DART AEROSPACE LTD	Work Order: 101363
Description: Crosstube Assembly (205/212/412 High Fwd)	Part Number: D212-664-141
Inspection Dwg: D212-664-141 Rev: D	Page 1 of 2

DRAWING NO. D212-664-141	TITLE XTUBE ASSY (205/212/412 HI FWD)	REV. D	DART AEROSPACE LTD ENGINEERING ORDER		D.E.O. NO. D212-664-141-D-1	SHEET NO. SHEET 1 OF 2	SCALE NTS
DRAWN	CHECKED	UP	MFG. APPR.	ER	APPROVED	MP	DE APPR.
DATE 11.04.07	DATE 11.04.11		DATE 11.04.12		DATE 11/04/12		DATE 11.04.12

DRAWING NO. D212-664-141	TITLE XTUBE ASSY (205/212/412 HI FWD)	REV. D	DART AEROSPACE LTD ENGINEERING ORDER	D.E.O. NO. D212-664-141-D-1	SHEET NO. SHEET 2 OF 2	SCALE NTS
DRAWN	CHECKED <i>CP</i>	MFG. APPR. <i>CE</i>	APPROVED <i>WAP</i>	DE APPR. <i>WAP</i>		
DATE 11.04.07	DATE 11.04.11	DATE 11.04.12	DATE 11/04/12	DATE 11.04.12

**D212-664-141/-141B
ASSEMBLY DETAIL**

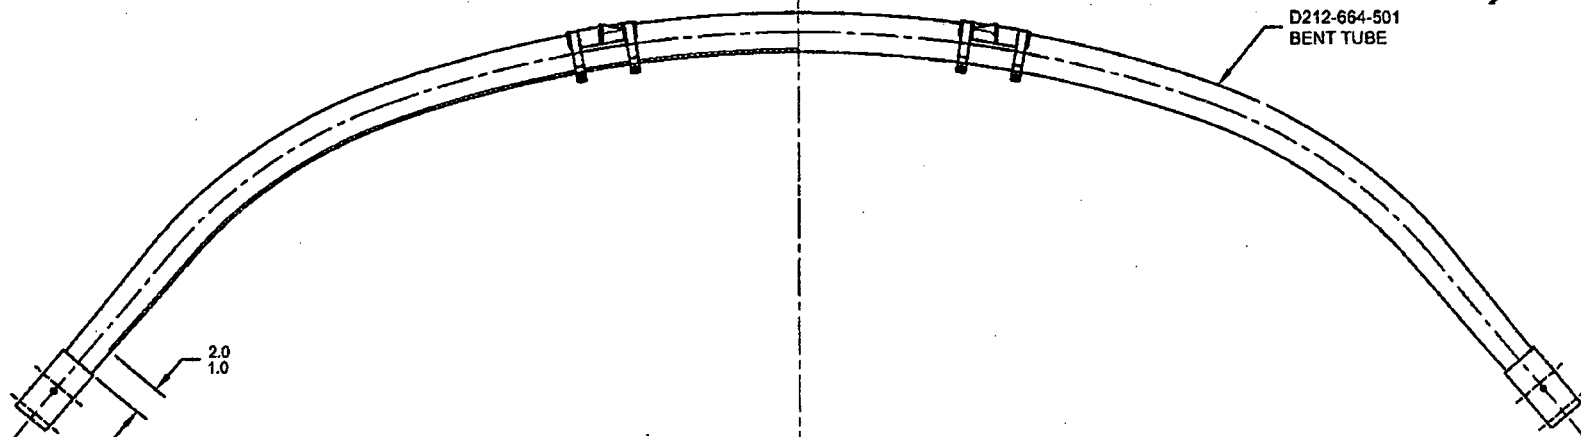
PURPOSE:

ADD AN INSPECTION WINDOW TO UNDERSIDE OF CROSSTUBE.

NOTES 2 OF SHEET 1 IS AMENDED AS FOLLOWS:

- 2) FINISH: CHEMICAL CONVERSION COAT PER DART QSI 005 4.1
PRIME INSIDE AND OUTSIDE PER DART QSI 005 4.2
MASK UNDERSIDE OF CROSSTUBE AS SHOWN (HATCHED AREA) AND
PAINT OUTSIDE PER DART QSI 005 4.2
REMOVE MASKING AND APPLY CLEAR COAT

- 2) FINISH: CHEMICAL CONVERSION COAT PER DART QSI 005 4.1
PRIME INSIDE AND OUTSIDE PER DART QSI 005 4.2
PAINT OUTSIDE PER DART QSI 005 4.2

MASK AREA PRIOR TO PAINTING,
REMOVE MASKING AFTER PAINT
AND APPLY CLEAR COAT
